JOHN SEVIER FOSSIL PLANT - ANNUAL INSPECTION OF WASTE DISPOSAL  
AREAS

**JOHN SEVIER FOSSIL PLANT (JSF)  
NPDES PERMIT NO. TN0005436  
ANNUAL ASH POND DIKE INSPECTION  
2000**

Photo 1. Looking East. Current Stacking Area.

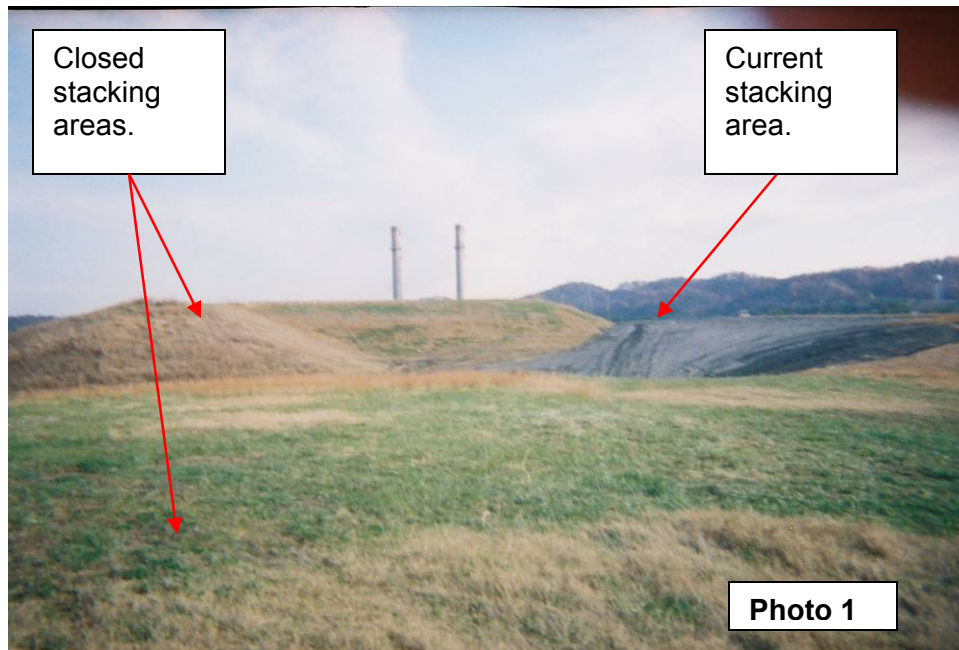
All fly ash that is not marketed commercially is dry stack in the southeast portion of this area. Except for the active stacking area of about 30 acres the dry fly ash stack has been covered with earth, seeded, and is developing a vegetative cover (Photo 1).

Photo 3. Looking Southeast. Sediment Pond for Dry Ash Stack.

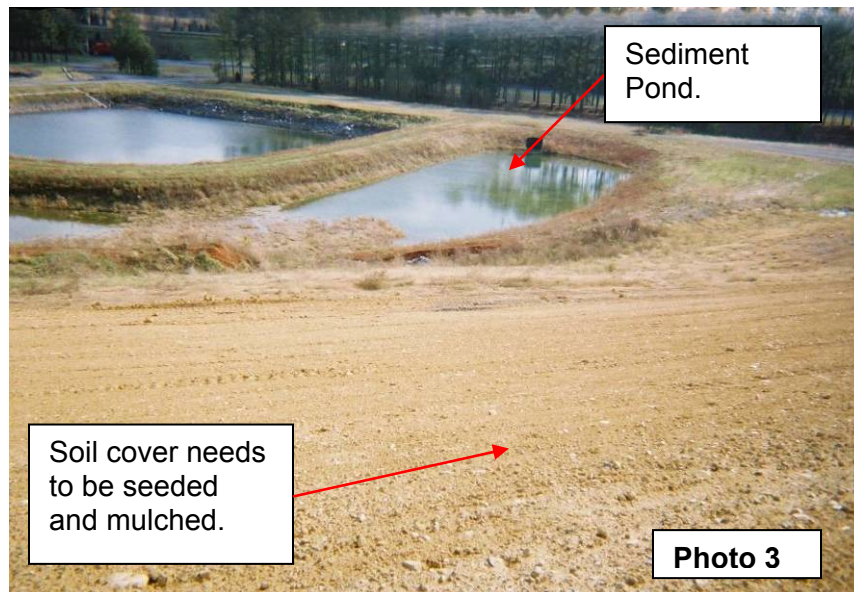
The sediment pond located in the southeast corner, beside the chemical ponds was cleaned in 2006. Since then, the plant has controlled the sediment in the pond well. At time of inspection, the south ditch was full and needed cleaning. The slopes in the sediment pond are all below grade and in good condition. The slope just above the pond was freshly graded and covered with soil, but no vegetation (Photo 3). The sediment in the pond should be removed to ensure it can operate as designed and the new slope above the pond should be seeded and mulched as soon as possible.

Photo 4. Erosion Ditch.

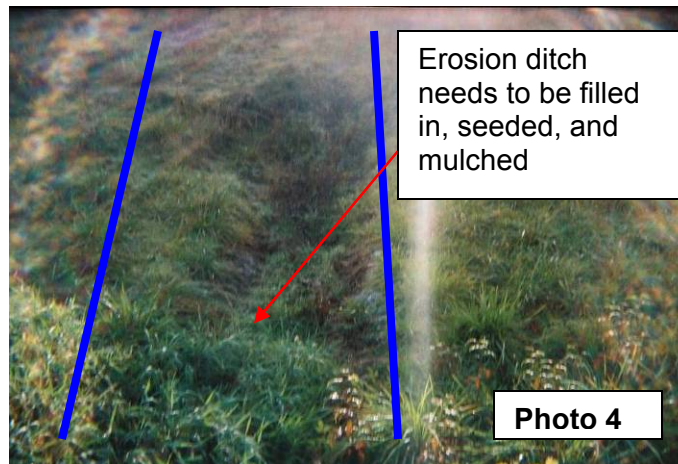
The north side of the stack along the river has good vegetative cover and appears to be stable. However, an animal burrow was noted at coordinates N 735092.220 E 2890091.437. It should be filled in with clay, seeded and mulched. There was also an erosion ditch in the first dike lift starting at coordinate N 734948.036 E 2889943.705 and end of ditch coordinate N 734977.298 E 2889908.436. The ditch was about 4 feet wide by 12 feet long and about 2 feet deep (Photo 4). This ditch also needs to be filled in with clay, seeded, and mulched.

Photo 6. North Side of Dry Stack. Slough in 2007.

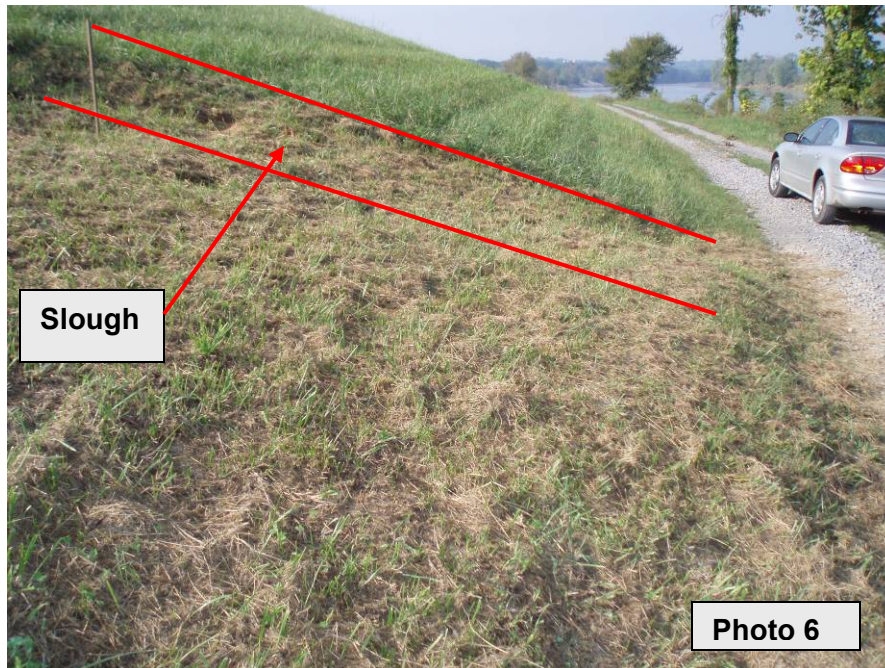
A slough (50' x 25') was discovered in the lower slope of the ash stack, near the river, in September 2007 and EDS was called to investigate the cause (Photo 6). EDS and Central Support and Repair (CS&R) dug in the area but were unable to determine the cause. Excavation in the area of the slough found no water or wet soul. The top three, or so, feet of material was dry (Photo 7).

Photo 13. Bottom Ash Pond. New Dredge Cell Dike and Skimmer.

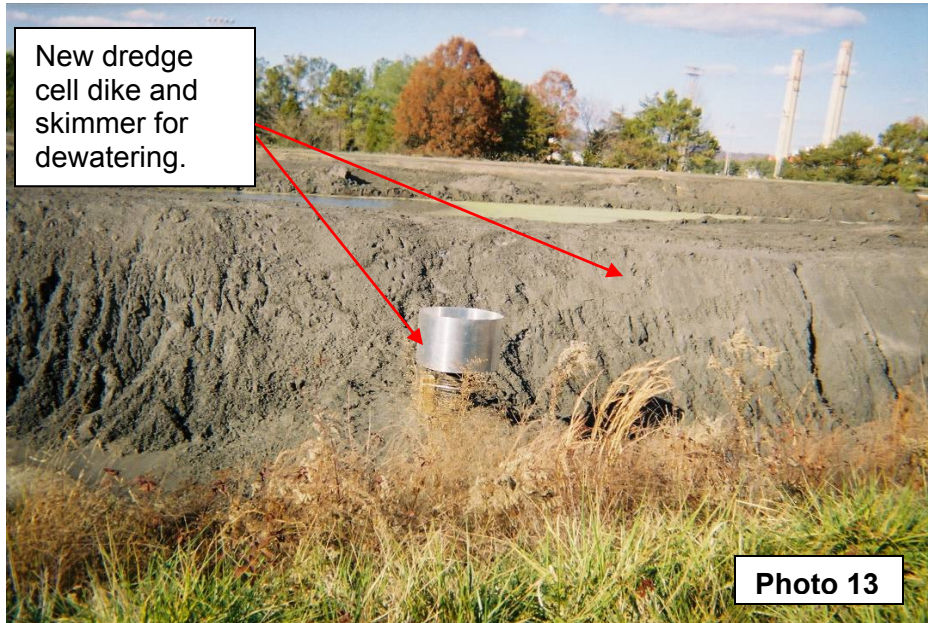
EDS recommends against the use of this dredge cell in the condition found during the inspection. We do not believe it will be stable enough to withstand internal water pressure. The slopes should be flattened to 3H:1V and compacted to at least 90% of maximum density before use. Compaction testing should be done to ensure the minimum density is achieved. We are also unsure the discharge structures can pass storm water and dredge flow. Since there is no emergency spillway, this is a concern.
